DATE ~~R~~ Feb.28/02**V2500-A1/A5 SERIES PROPULSION SYSTEMS SERVICE BULLETIN**

This document transmits Revision 1 to Service Bulletin EV2500-73-0163

**V2500-ENG-73-0163**  
 Transmittal - Page 1 of 2

ENGINE – PROVIDE NEW ELECTRONIC ENGINE CONTROL SUPPORT SHIMS

Location of Shims  
Fig.1

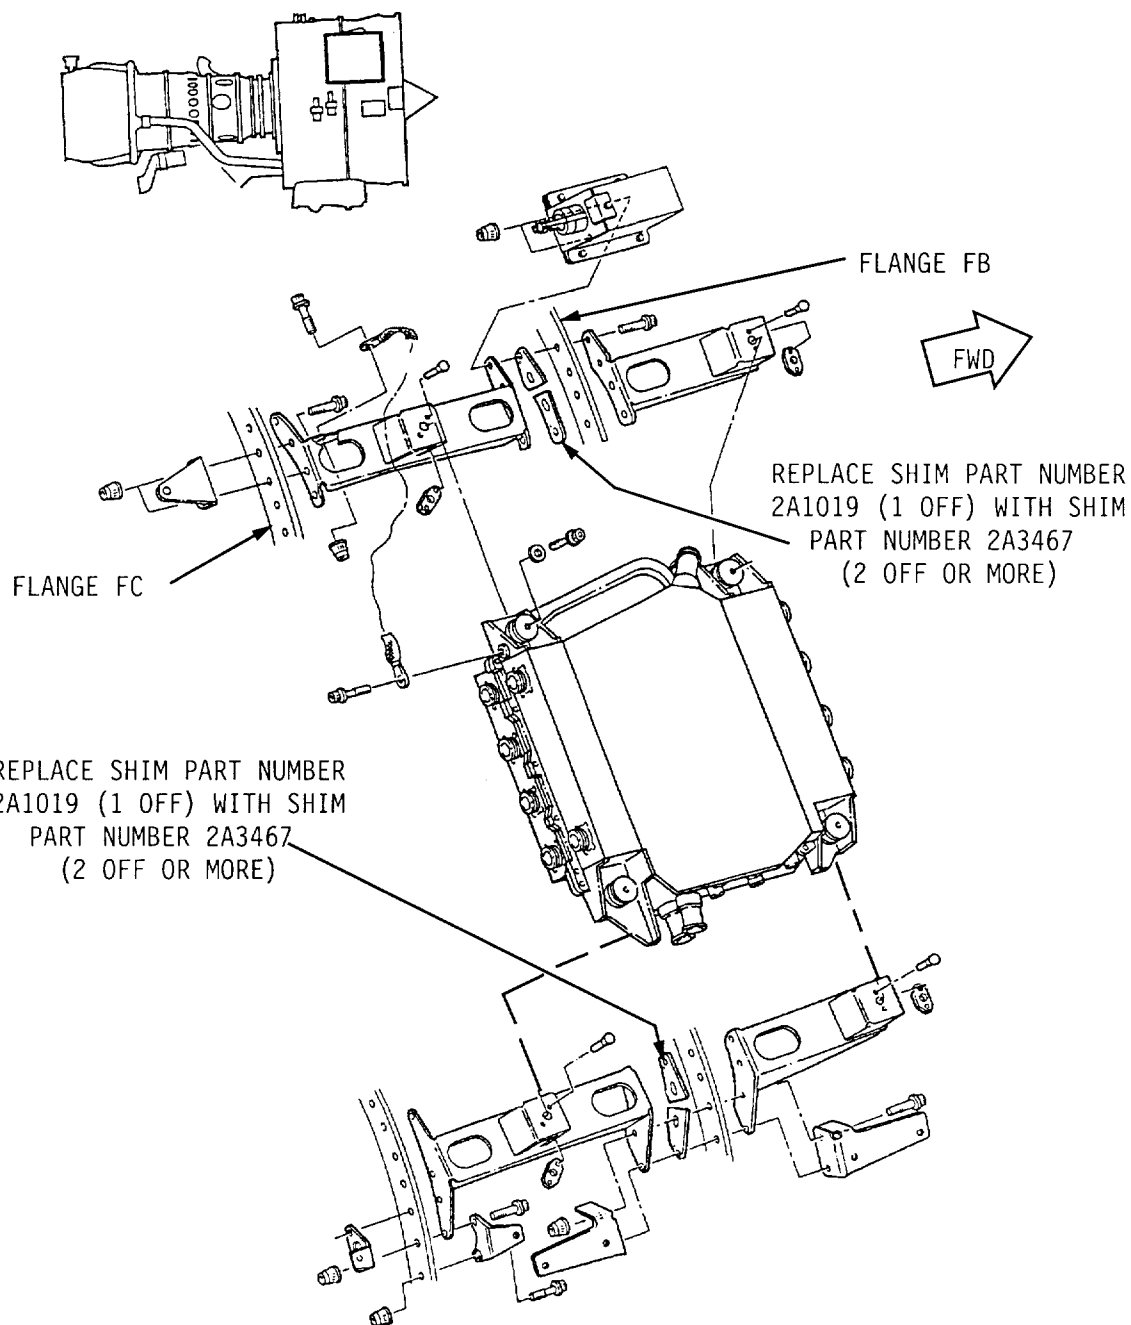
- R (1) Replace the laminated shim 2A1019 (1 off) with Shims 2A3467 (2 off or more  
R as required). For the correct removal/installation procedures, refer to  
R Engine Manual 72-00-32.
- (2) Mount the EEC support W on Flange FC. Use standard procedures.
- (3) Measure the gap two places adjacent to bracket gussets between the forward surface of the EEC support W and flange FB.
- (4) Fill the gaps with shims as required to produce a clearance of 0.000 to 0.011 inch (0.000 to 0,279 mm.) loose fit.

Family Tree – Electronic Engine Control Support Shims Ref. Catalog Sequence No.  
73-22-34. Fig. 01 Item 250  
Fig.2

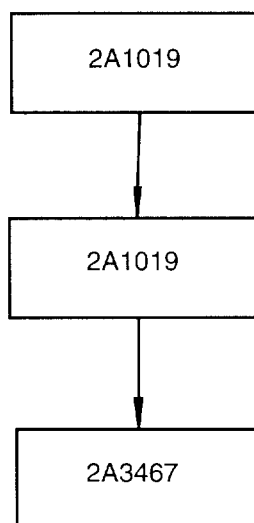
V2500-ENG-73-0163  
ENGINE – PROVIDE NEW ELECTRONIC  
ENGINE CONTROL SUPPORT SHIMS
